# Rezoning Transportation Analysis

Petition Number: 2019-173

Date	Description
01-17-2020	First Review
05-20-2020	Second Review (WB)
09-22-2020	Third Review

## SECTION A - A PROPOSED ROAD IMPROVEMENTS (FUTURE BY OTHERS)

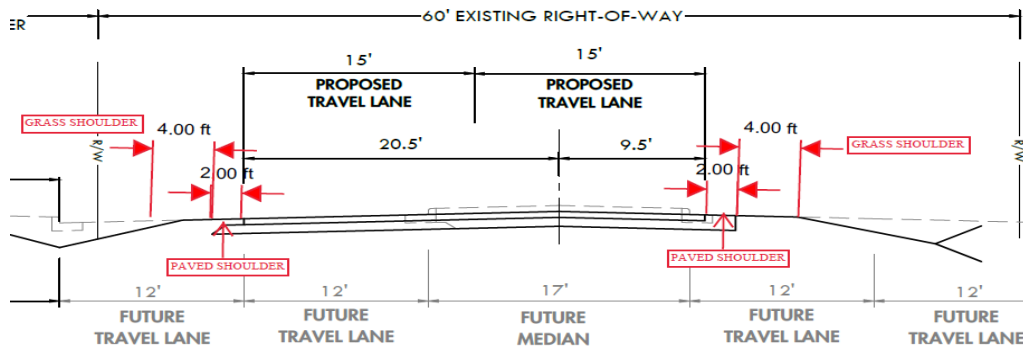
6. ~~New Comment based on revised site plan 05-11-2020:~~ The petitioner should revise the site plan and conditional notes to commit to construct 2-12' lanes with 2' paved shoulders and 4' grass shoulders. for Section A-A. **Outstanding:** Add a note stating the final details will be determined during the permit review process to include input from other departments including but not limited to CDOT, General Services, Charlotte Fire Department, and NCDOT. Also include that any applicable ordinance requirements in addition to what is shown on proposed cross-sections may be required.

**Outstanding:** Add a note stating the final details will be determined during the permit review process to include input from other departments including but not limited to CDOT, General Services, Charlotte Fire Department, and NCDOT. Also include that any applicable ordinance requirements in addition to what is shown on proposed cross-sections may be required.

SECTION B - B

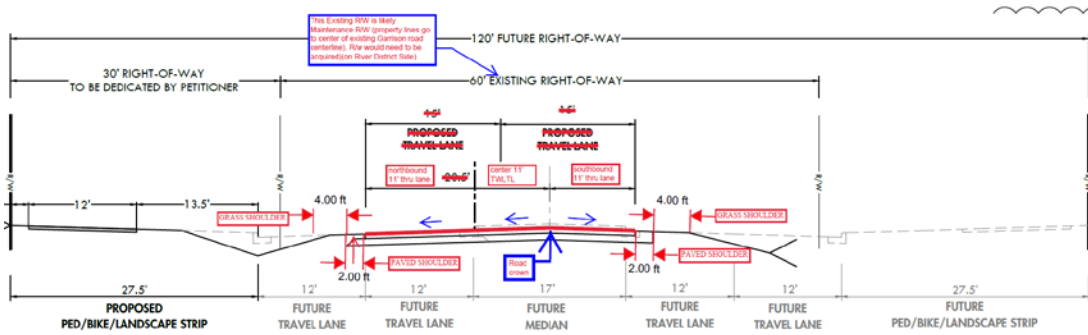
- a. **New Comment based on revised site plan 08-24-2020:** Revise Section B-B to the redlines below, reflecting the latest coordination between CDOT and NCDOT. A three-lane section with a center two-way left-turn lane will provide median space for left turns into the proposed access points for Development Area A. CDOT encourages the petitioner to consider condensing the number of access points for Development Area A on the along the Realigned Garrison Road.

## SECTION C - C

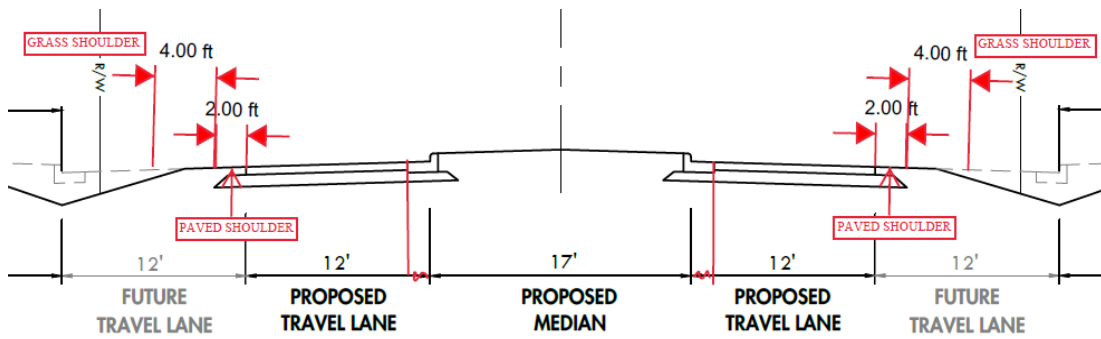
8. ~~New Comment based on revised site plan 05-11-2020:~~ Cross-section C-C depict the general intent of a 3-lane section (2 travel lanes and center turn lane and/or planted median) and a shared-use path for an interim version of future Garrison Road. The petitioner should revise the site plan and conditional notes to commit to construct 2' paved shoulders and 4' grass shoulders.

**Outstanding:** Add a note stating the final details will be determined during the permit review process to include input from other departments including but not limited to CDOT, General Services, Charlotte Fire Department, and NCDOT. Also include that any applicable ordinance requirements in addition to what is shown on proposed cross-sections may be required.

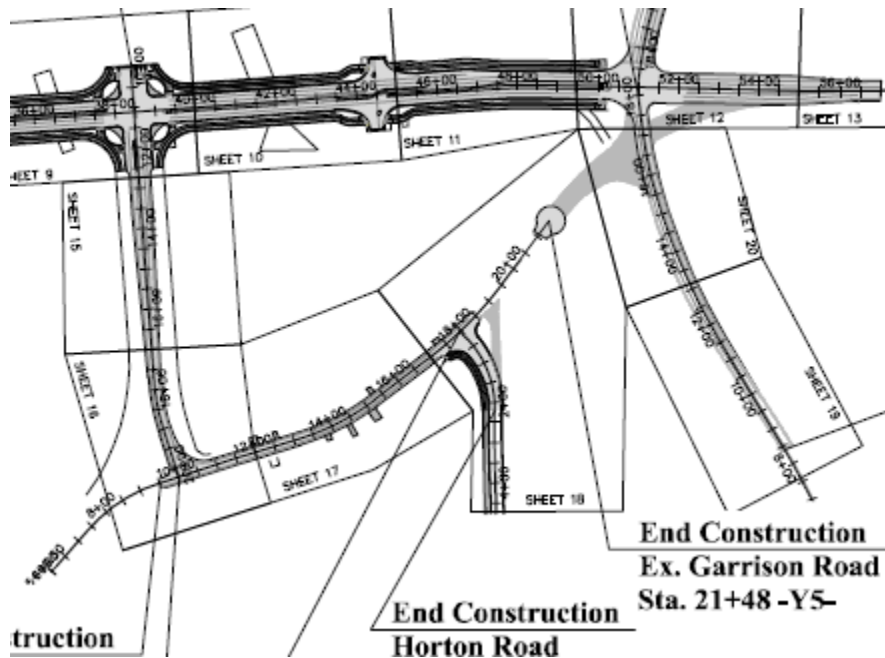
10. **New Comment based on revised site plan 08-24-2020:** Revise the site plan and conditional note(s) to clarify the pavement sections that will be constructed by the petitioner, to be consistent with CLDSM standard detail number 11.09. The pavement schedule, as copied from the West Boulevard Extension plans for the Realigned Garrison Road typical cross sections, are provided below for reference.

(C1)	PROP. 3.0 INCHES ASPHALT CONCRETE SURFACE COURSE, TYPE S9.5C, AT AN AVERAGE RATE OF 168 LB/SY IN EACH OF TWO 1.5-INCH LIFTS
(D1)	PROP. 4 INCHES (MIN) ASPHALT CONCRETE INTERMEDIATE COURSE, TYPE I19.0C, AT AN AVERAGE RATE OF 456 LB/SY
(E1)	PROP. 8.0 INCHES ASPHALT CONCRETE BASE COURSE, TYPE B25.0C, AT AN AVERAGE RATE OF 399 LB/SY IN EACH OF TWO EQUAL LIFTS
